STATE OF CONNECTICUT
CONNECTICUT SITING COUNCIL

DOCKET NO. 440

RESPONSES OF NEW CINGULAR WIRELESS TO CONNECTICUT SITING COUNCIL
PRE-HEARING QUESTIONS SET I

ATTACHMENT 1

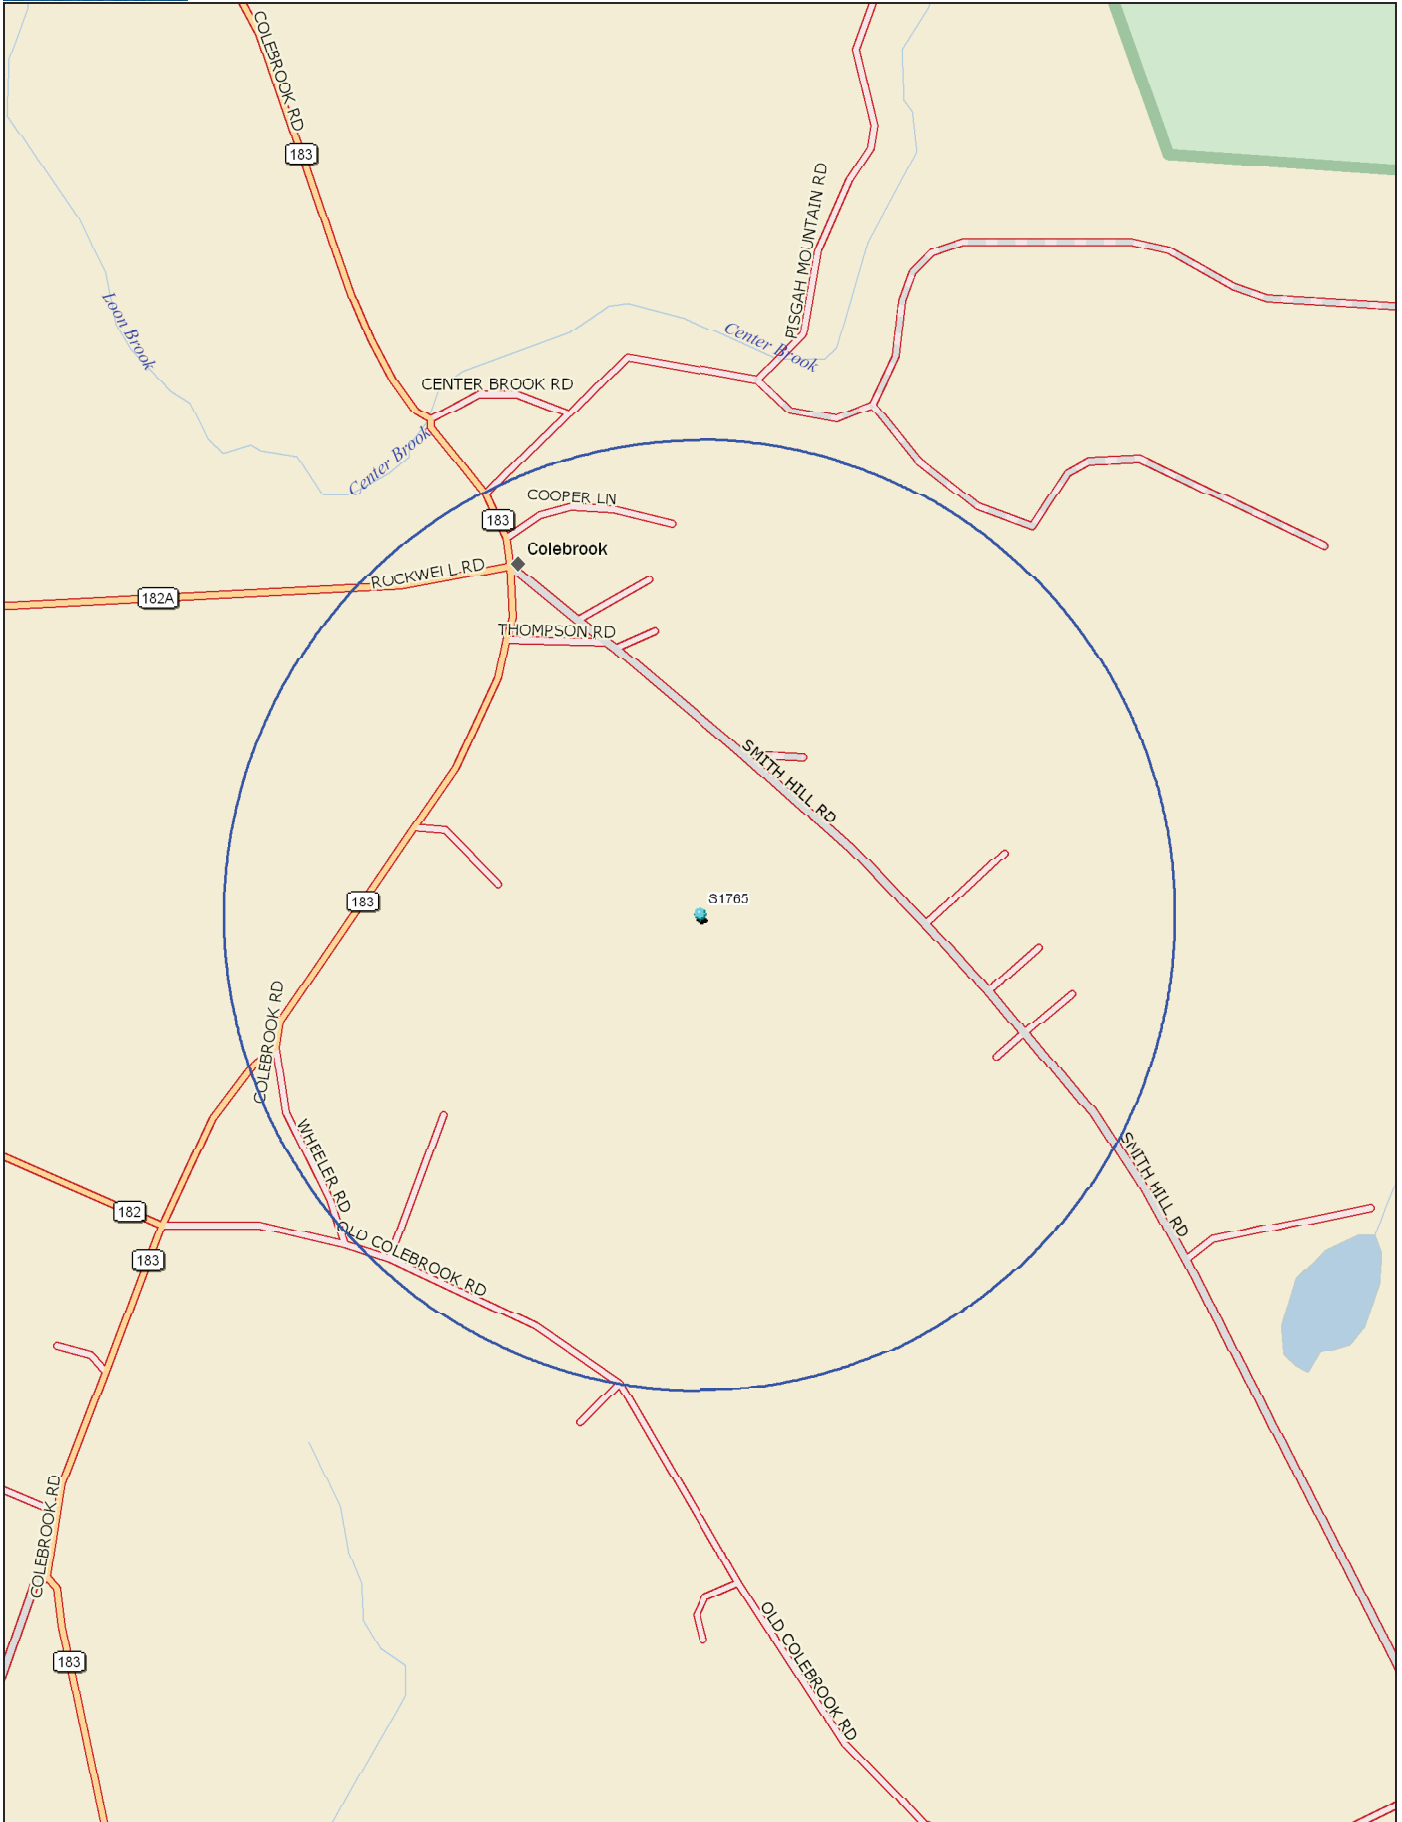
- Q4. When was AT&T's search ring first initiated for a tower in this area? Provide the size, shape, and location of the center of the search ring.

A4. AT&T issued a search ring for providing reliable service to this area of the State in April of 2010. As detailed in the Application, AT&T commenced a municipal consultation in February of 2011 and then deferred filing of an Application with the Siting Council. AT&T funded continuation of the application process for the proposed Facility earlier this year.

A map of the search ring area is provided in Attachment 1.

Drive Test Scan Data
 and Dropped Calls

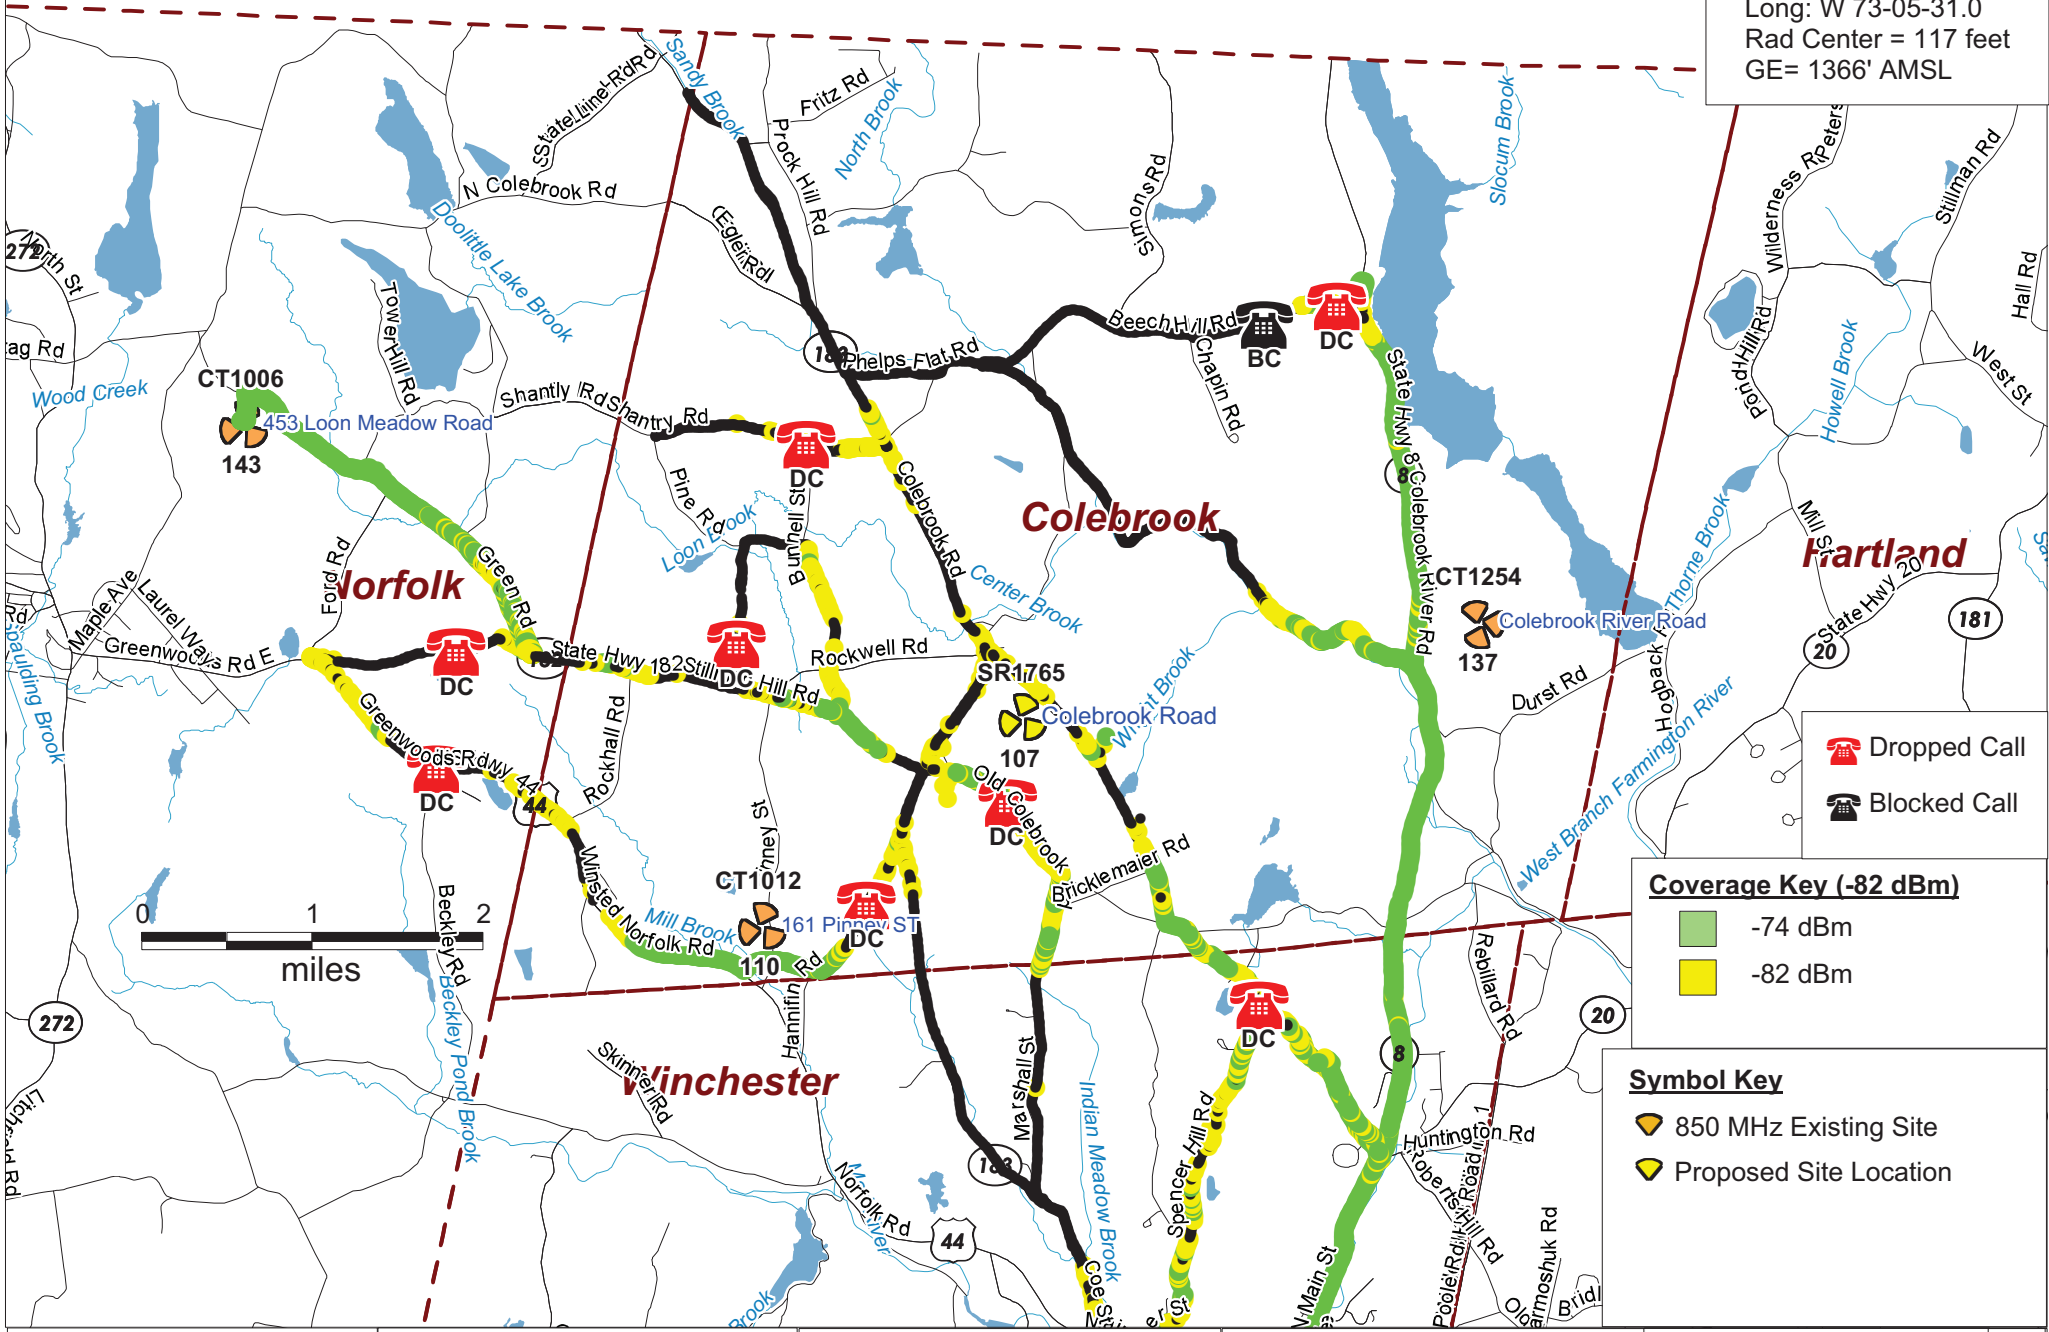
Q9. Does AT&T have any statistics on dropped calls in the vicinity of the proposed site? If so, what do they indicate? Does AT&T have any other indicators of substandard service in this area?

A9. Yes. AT&T's dropped call data on the two neighboring sites (AT&T Sites CT1006 and CT1012) and the sectors that face directly into the area where reliable service is needed indicate elevated voice and data drops. The data show that AT&T's network performance standards are not being met in the area where reliable service is needed. Included in Attachment 2 is a map of AT&T's drive data which also confirms that reliable service is not available in this area of Colebrook.

Existing and Proposed
@ 107 feet AGL Coverage

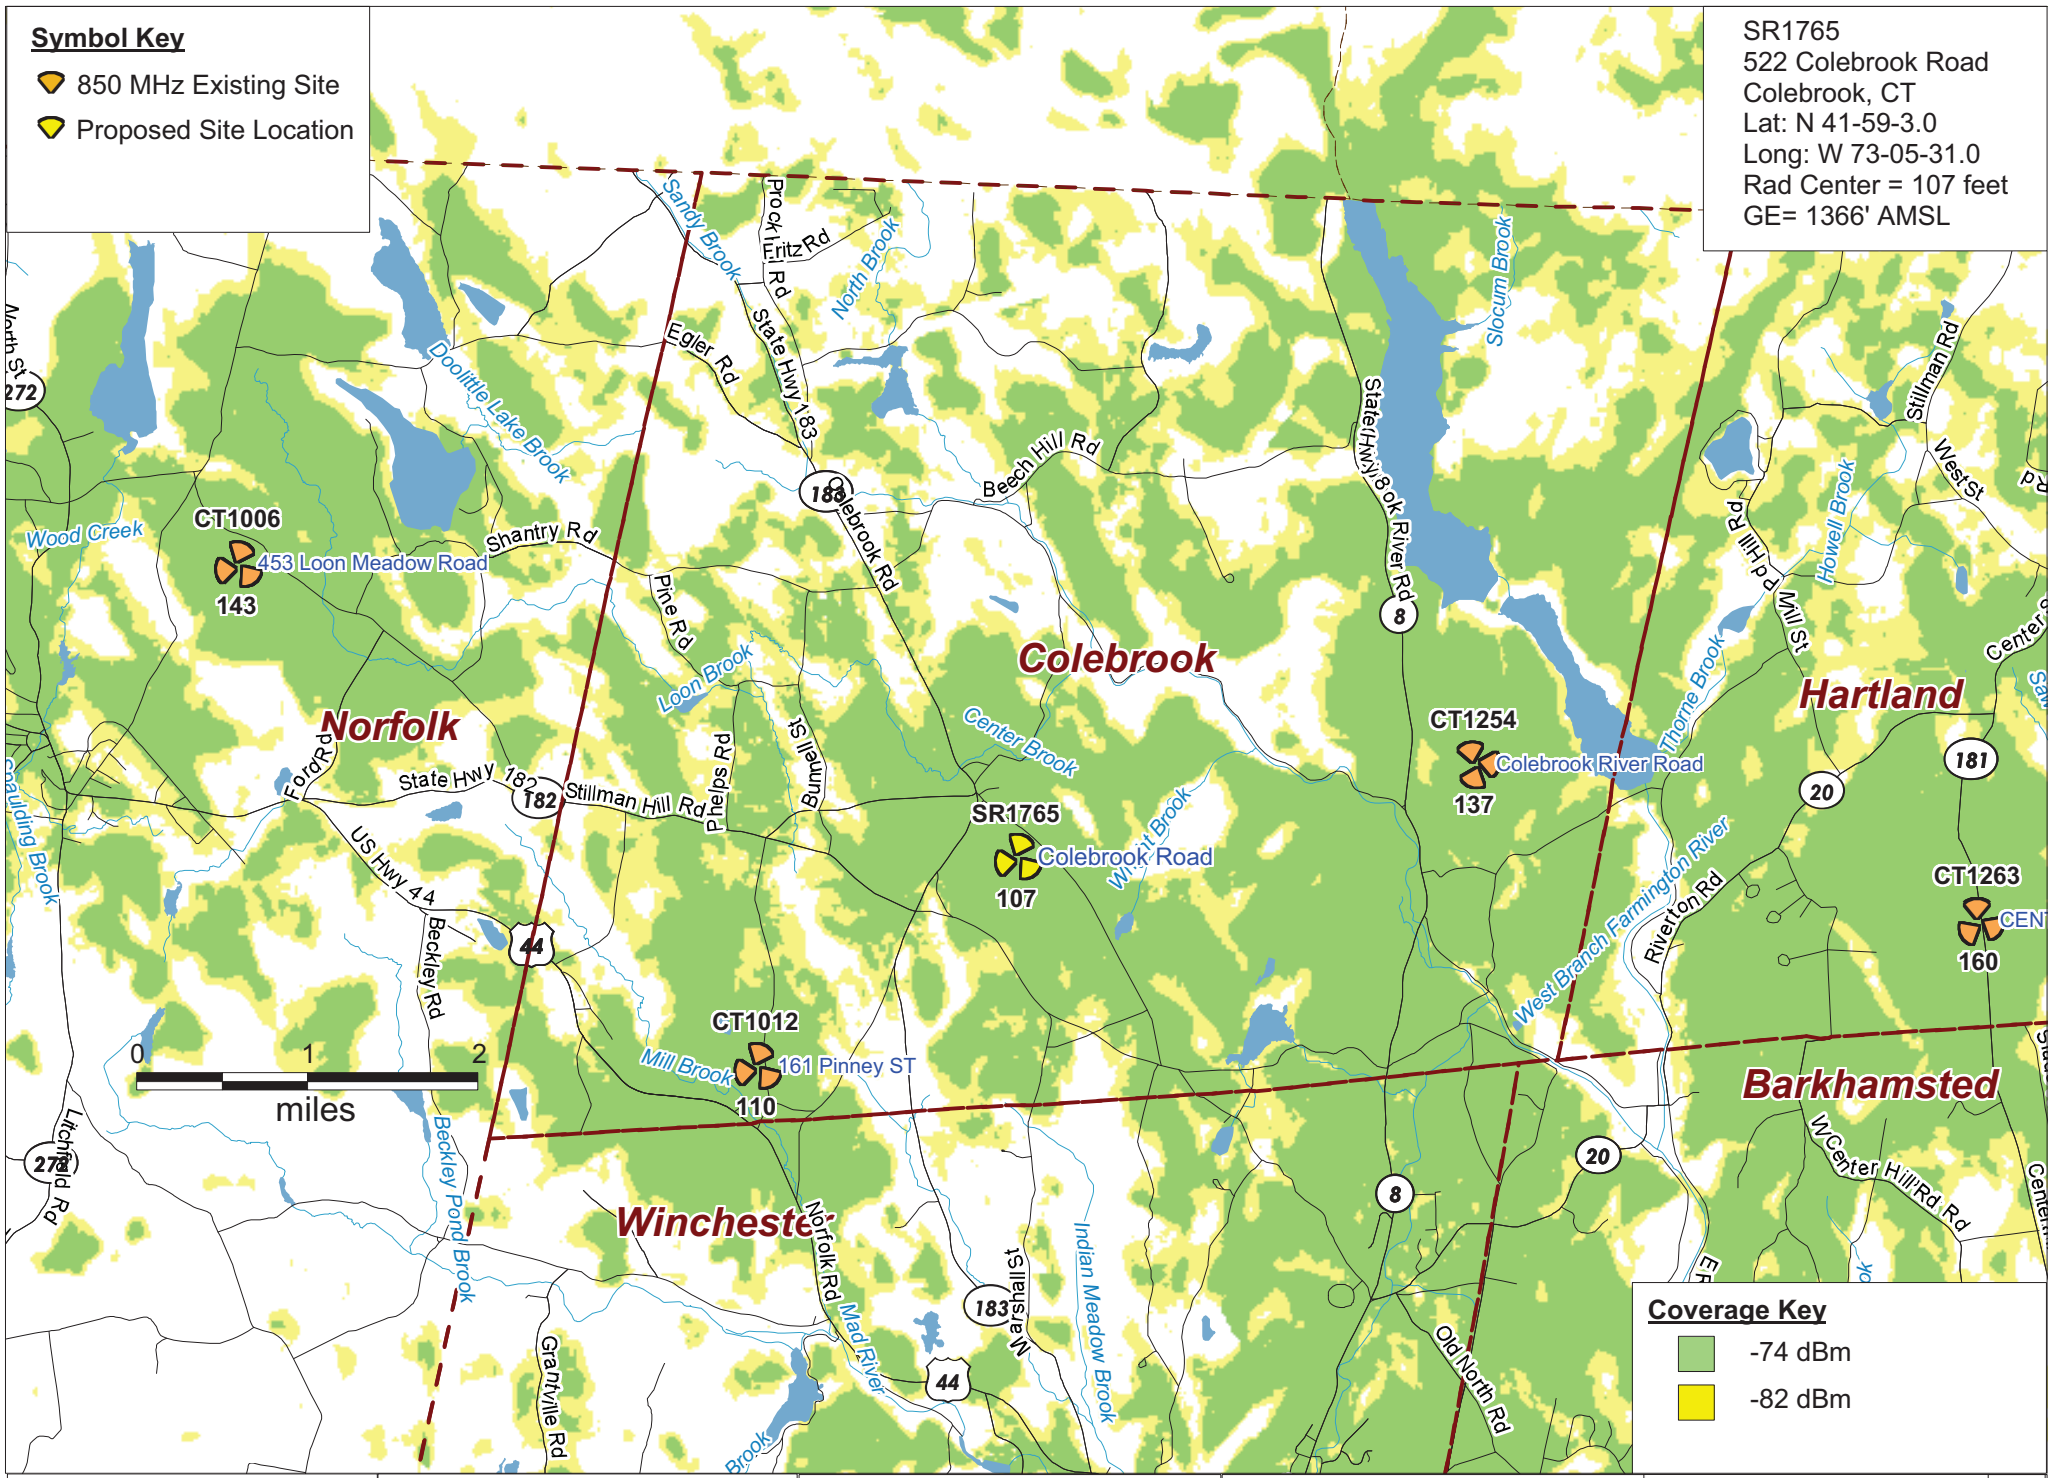
Q16. Using the same scale as the coverage plots in the Radio Frequency Analysis Report, provide separate coverage plots assuming the tower is ten and twenty feet shorter.

A16. Included in Attachment 3 are propagation maps depicting existing coverage and proposed coverage at antenna centerline heights of 107' AGL and 97' AGL (ten and twenty feet lower than the proposed antenna centerline height of 117' AGL). These propagation maps show gaps to the north and west, particularly along Routes 183 and 182.
